SEMINOLE COUNTY GOVERNMENT
 1101 EAST FIRST STREET, 2ND FLOOR, WEST WING
 SANFORD, FLORIDA 32771

PROJECT NAME:	VILLAGE PL - PRE-APPLICATION	PROJ #: 24-80000034
APPLICATION FOR:	DR - PRE-APPLICATION DRC	
APPLICATION DATE:	3/07/24	
RELATED NAMES:	EP BRENDA PEARCE	
PROJECT MANAGER:	KATHY HAMMEL (407) 665-7389	
PARCEL ID NO.:	03-21-29-5WA-0000-0010	
PROJECT DESCRIPTION	PROPOSED SPECIAL EXCEPTION FOR A NEW WATER METER SYSTEM INSTALLATION ON 75.97 ACRES IN THE PD ZONING DISTRICT LOCATED ON THE EAST SIDE OF VILLAGE PL, NORTH OF WEKIVA SPRINGS RD	
NO OF ACRES	75.97	
BCC DISTRICT	3: CONSTANTINE	
CURRENT ZONING	PD	
LOCATION	ON THE EAST SIDE OF VILLAGE PL, NORTH OF WEKIVA SPRINGS RD	
FUTURE LAND USE-	PD	
APPLICANT:	CONSULTANT:	
BRENDA PEARCE BLACK & VEATCH/SUNSHINE WATER 200 WEATHERSFIELD AVE ALTAMONTE SPRINGS FL 32714 (678) 656-5179 PEARCEB@BV.COM	N/A

PROJECT AREA ZONING AND AERIAL MAPS

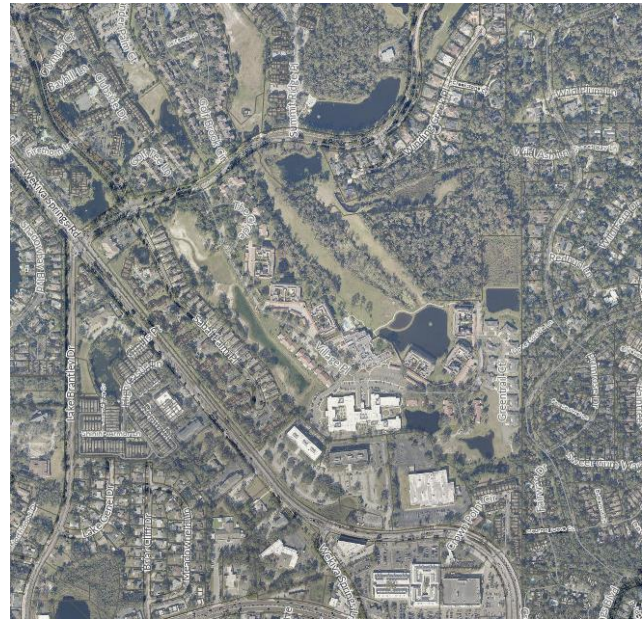
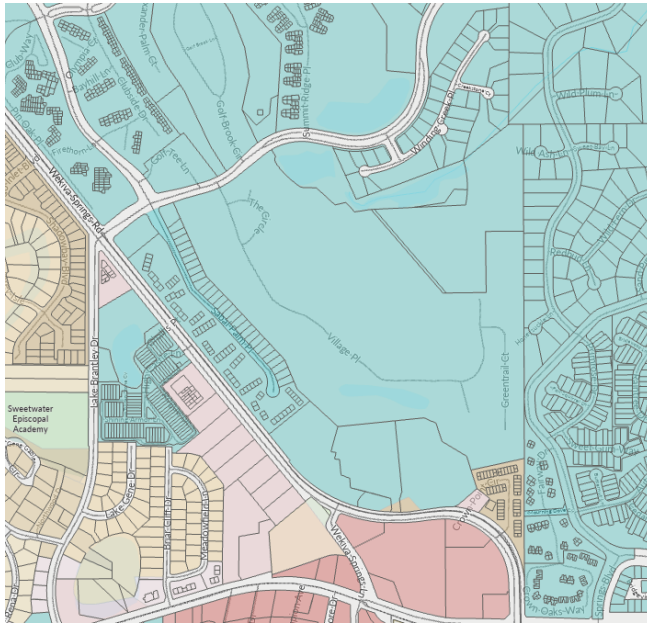
The parcel is located within unincorporated Seminole County and within the Village on the Green, Sabal Point Planned Development (PD).

The installation of a pole with an antenna for a new water metering system will require a Major Amendment to allow the use in the PD. A variance to the building/structure height of 35 feet may also be required.
